**Addendum No. 2
January 20, 2023**

Project: Baltic High School Addition
Baltic, South Dakota
Arch Project No. 2957

Architect: Architecture Incorporated

8.41

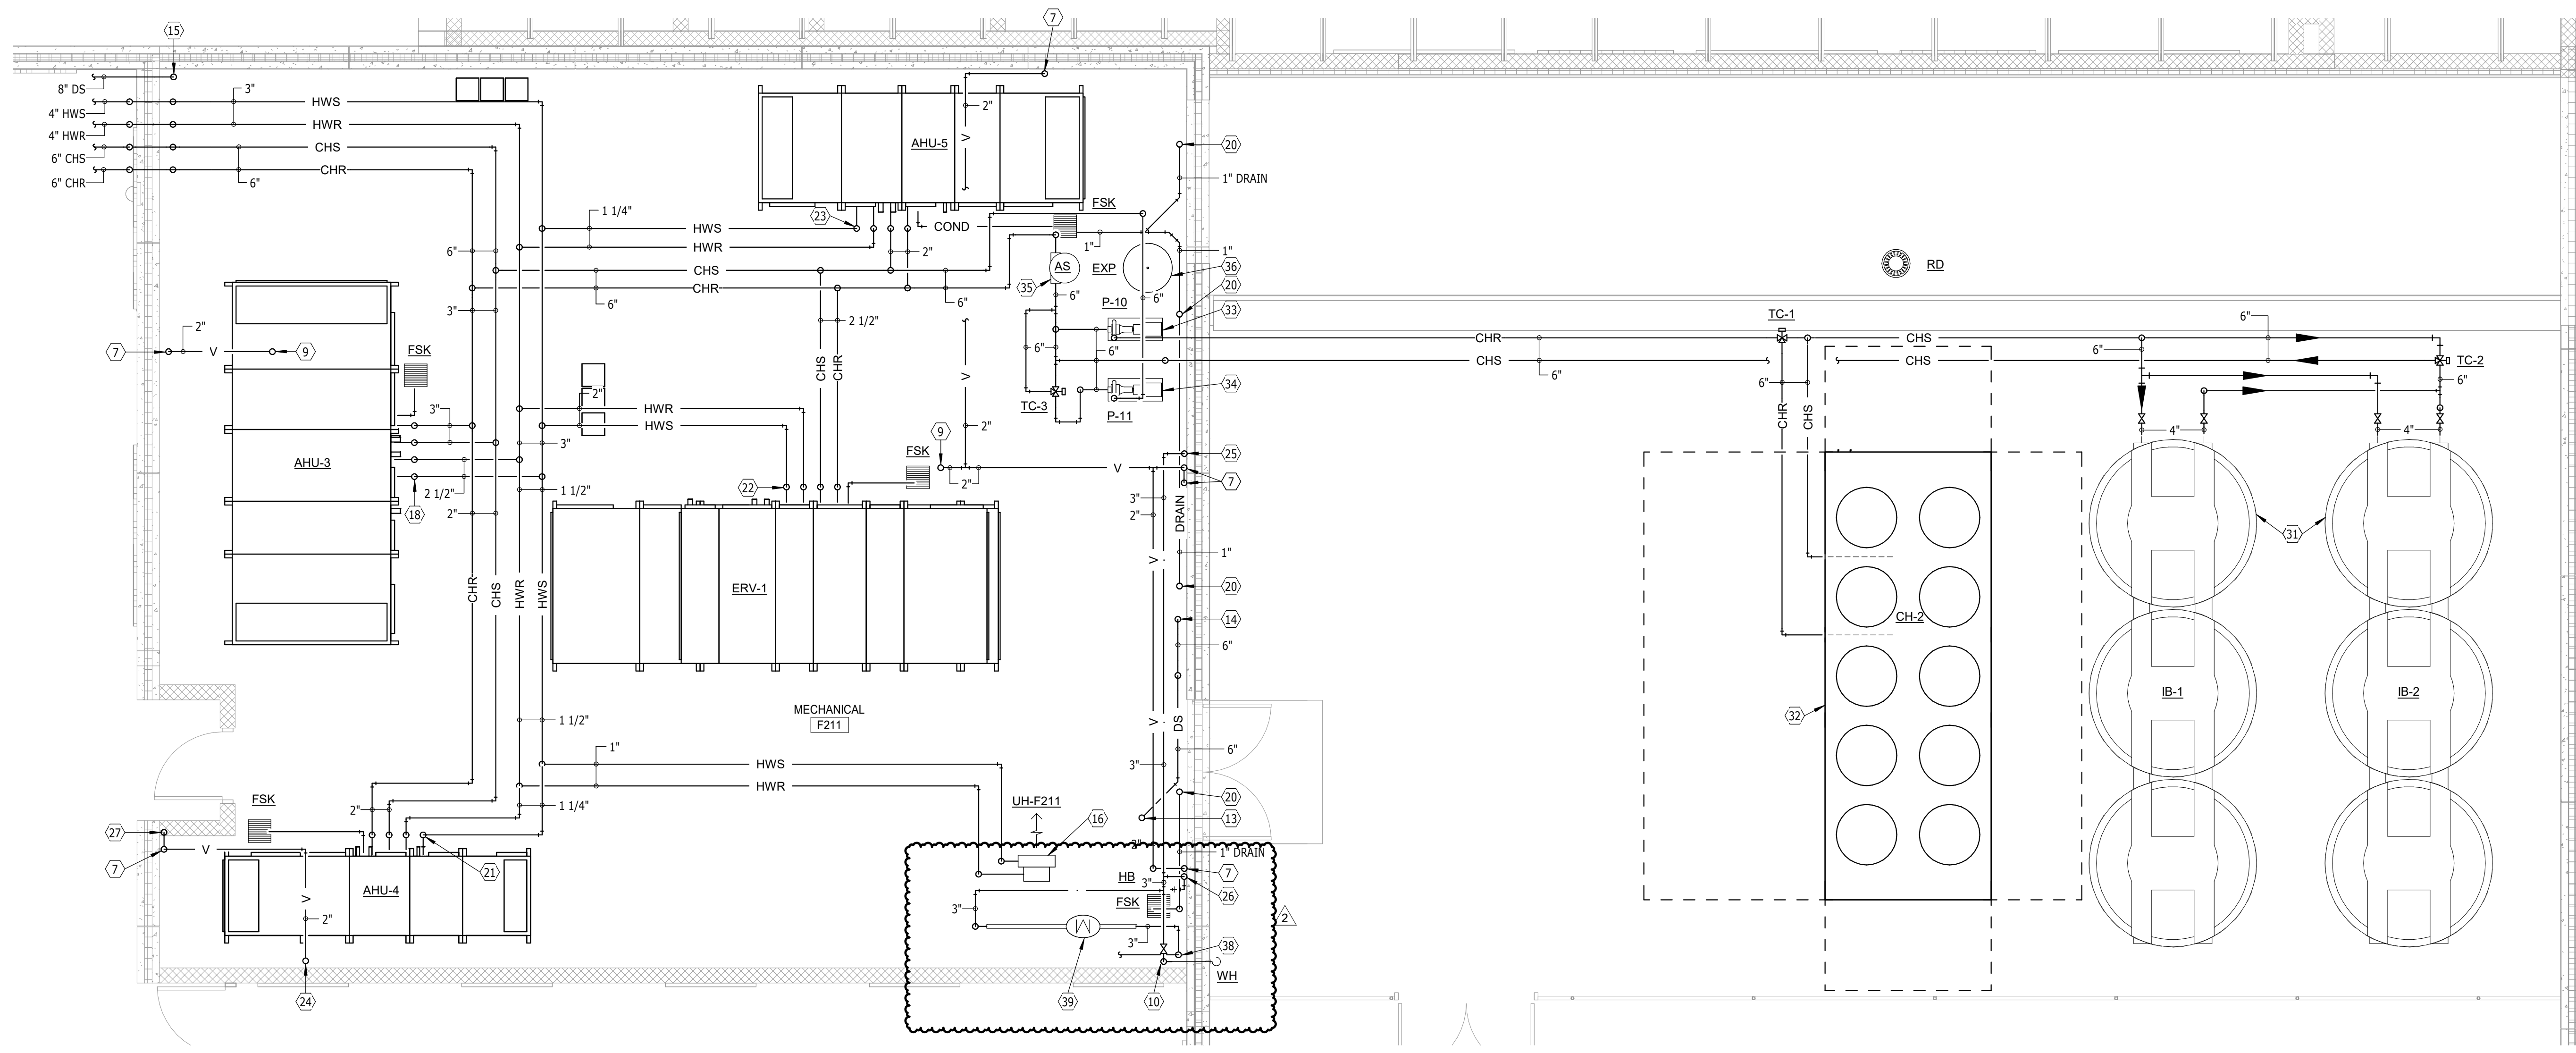
- 7) **SHEET 8.41 – ENLARGED FIRST FLOOR PLANS – AREAS E, F & G – PLUMBING & HEATING**
 - a) Enlarged First Floor Plan – Area E – Plumbing & Heating:
 - i) JAN E103: Modify location of mop sink, floor drain, infloor heat manifold & associated piping as indicated per revised drawing Sheet 8.41, Addendum 2, dated 1/20/23.

- b) Enlarged First Floor Plan – Locker Area F1 – Plumbing & Heating:
 - i) RR F127: Substitute plumbing fixture designation SH-2 for the SH-3 shown as indicated per revised drawing Sheet 8.41, Addendum 2, dated 1/20/23.

- ii) BOYS F129: Add water hammer arrestor as indicated per revised drawing Sheet 8.41, Addendum 2, dated 1/20/23.
 - c) Enlarged First Floor Plan – Locker Area F2 – Plumbing & Heating:

- i) RR F119: Substitute Plumbing Fixture Designation SH-2 for the SH-3 shown as indicated per revised drawing Sheet 8.41, Addendum 2, dated 1/20/23.
 - d) Enlarged First Floor Plan – Area G – Plumbing & Heating:

- i) JAN G105: Modify location of mop sink, floor drain, infloor heat manifold & associated piping as indicated per revised drawing Sheet 8.41, Addendum 2, dated 1/20/23.

- ii) JAN G105: Add water hammer arrestor as indicated per revised drawing Sheet 8.41, Addendum 2, dated 1/20/23.
 - e) Reference revised mechanical drawing Sheet 8.41 attached to the end of this addendum for changes identified above.

8.42

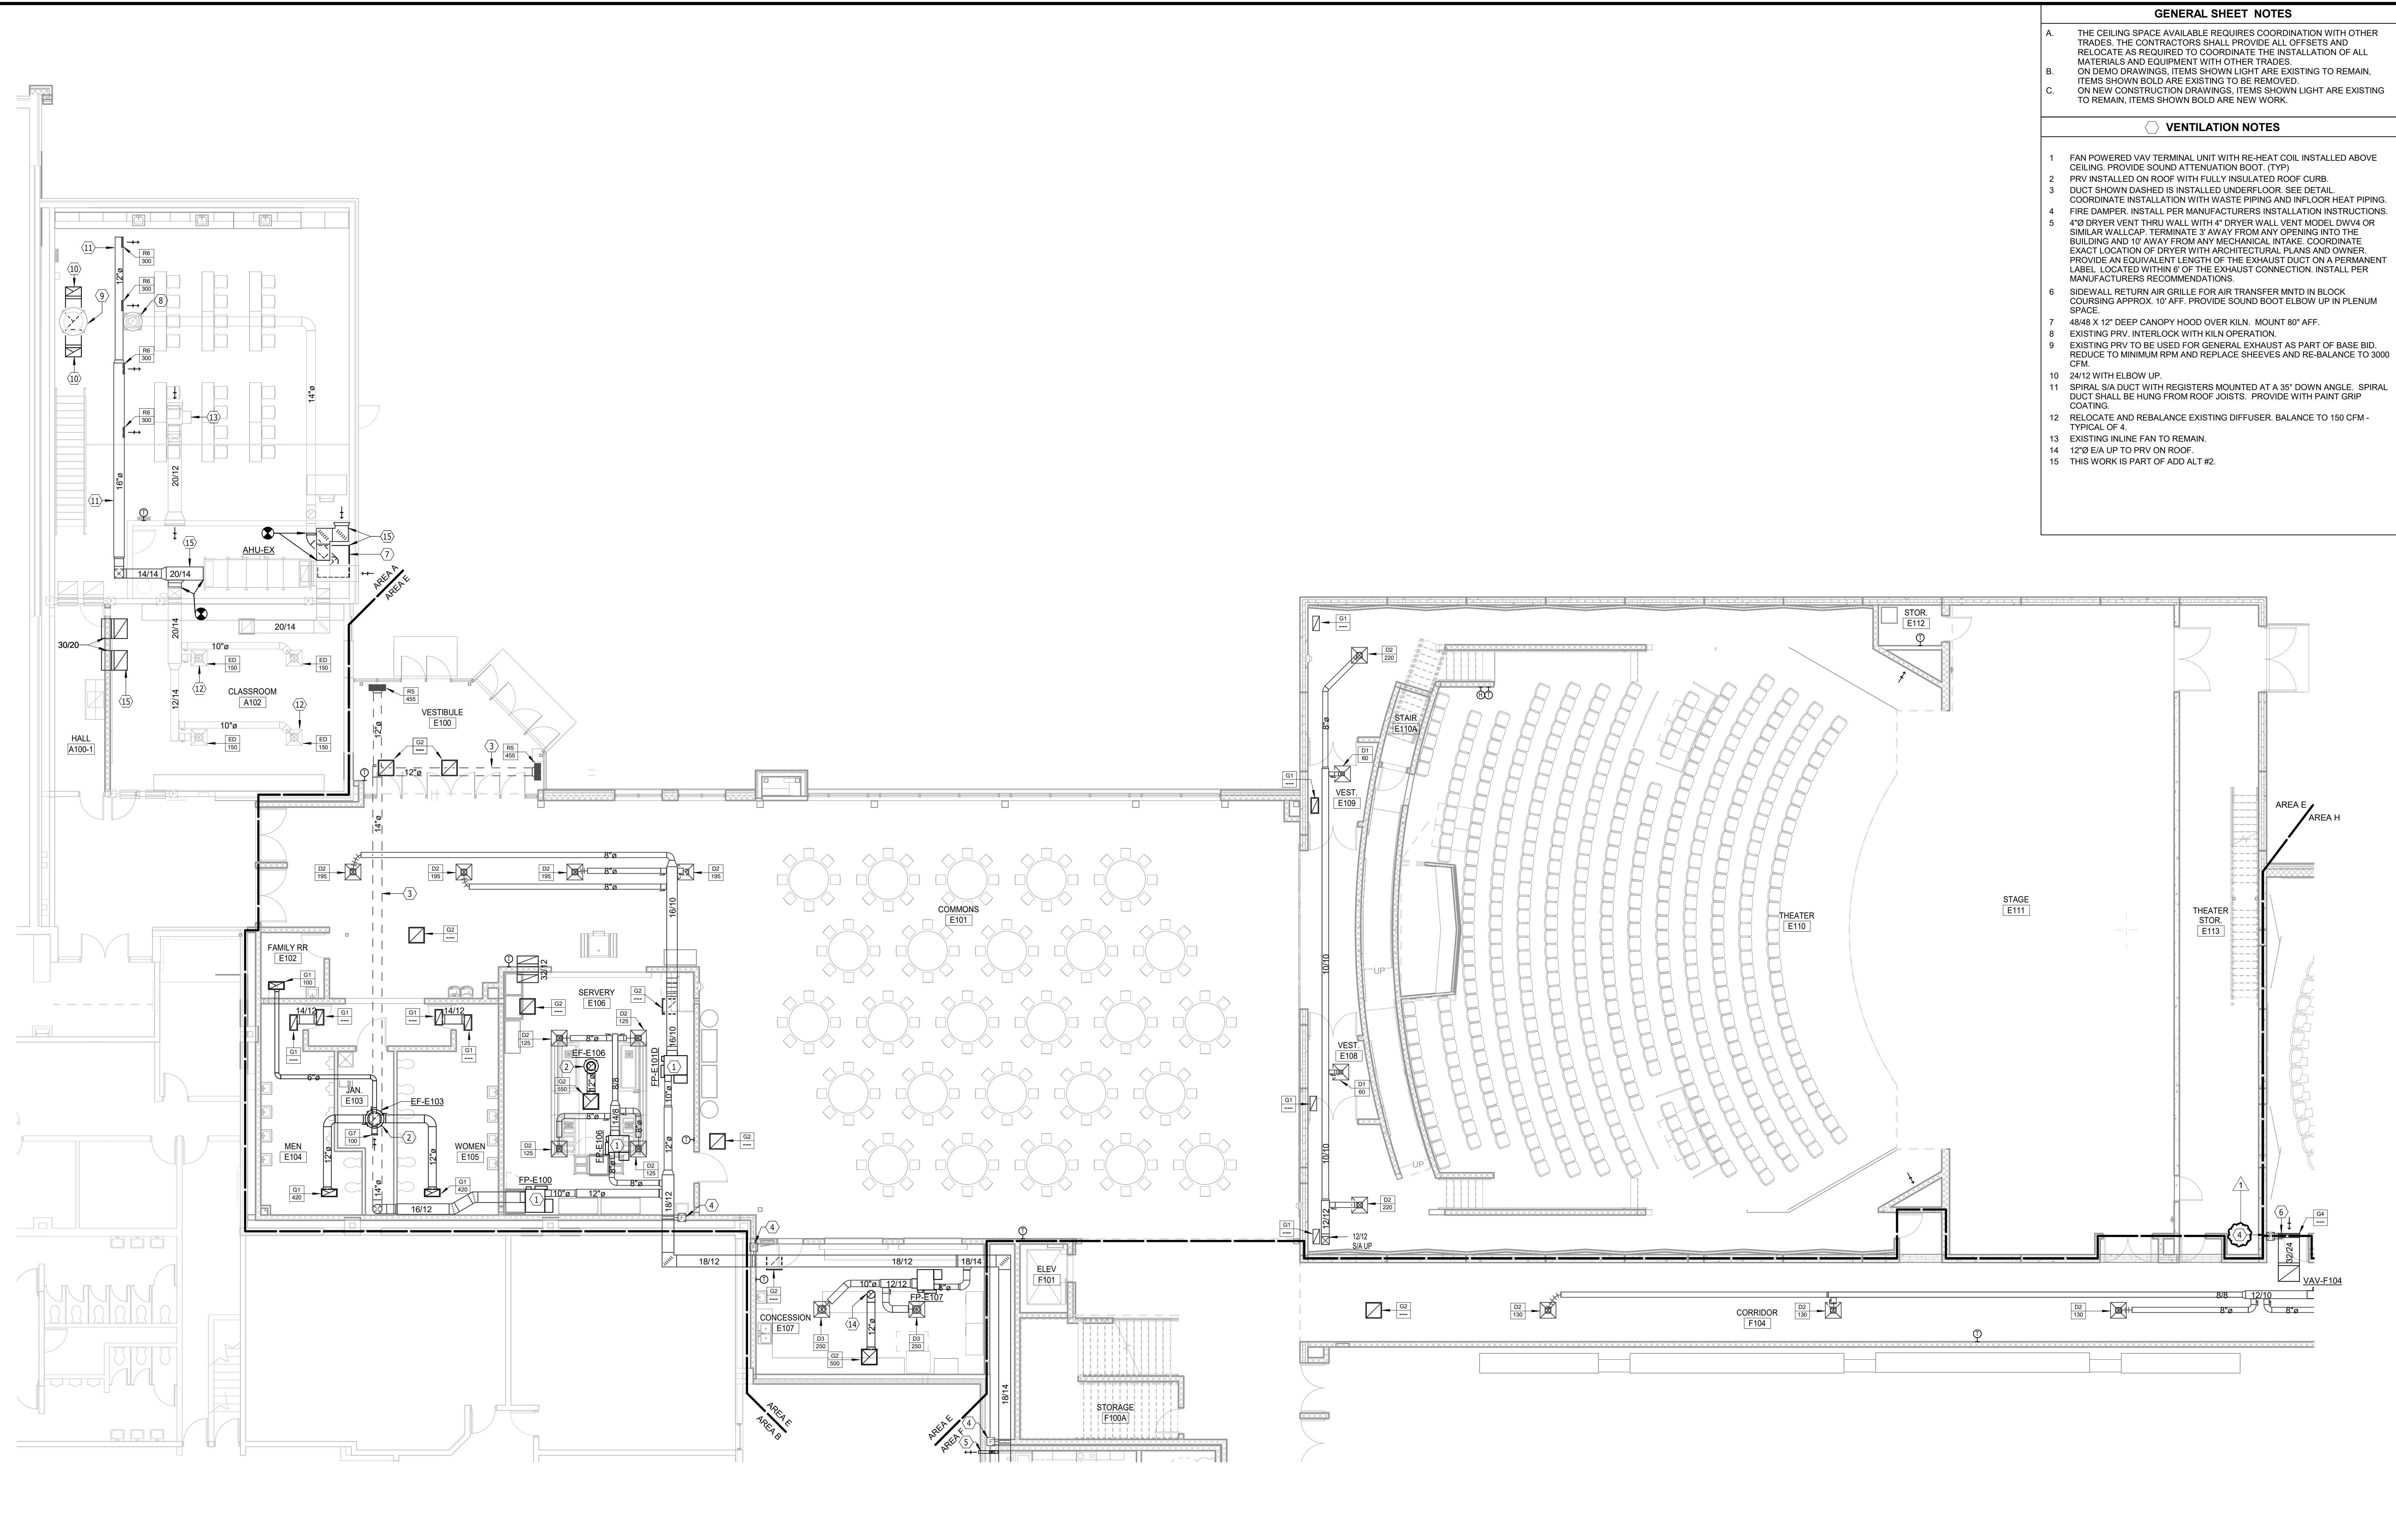
- 8) SHEET 8.42 – ENLARGED SECOND FLOOR PLANS – AREAS F & G – PLUMBING & HEATING
- a) Enlarged Second Floor Plan – Area F – Plumbing & Heating:
 - i) MECH F211: Modify water meter piping & fire protection and water service piping as indicated per revised drawing Sheet 8.42, Addendum 2, dated 1/20/23.

- b) Enlarged Penthouse Plan – Area G – Plumbing & Heating:
 - i) Omit unit heater UH-PENT 1 (and all associated piping) in Mechanical Penthouse G300.
 - (1) NOTE: This change is not accounted for on revised drawing Sheet 8.42 included with Addendum #2; omit unit heater as specified here.

- c) Enlarged Second Floor Plan – Area G – Plumbing & Heating:
 - i) JAN G216: Modify mop sink location & associated piping as indicated per revised drawing Sheet 8.42, Addendum 2, dated 1/20/23.
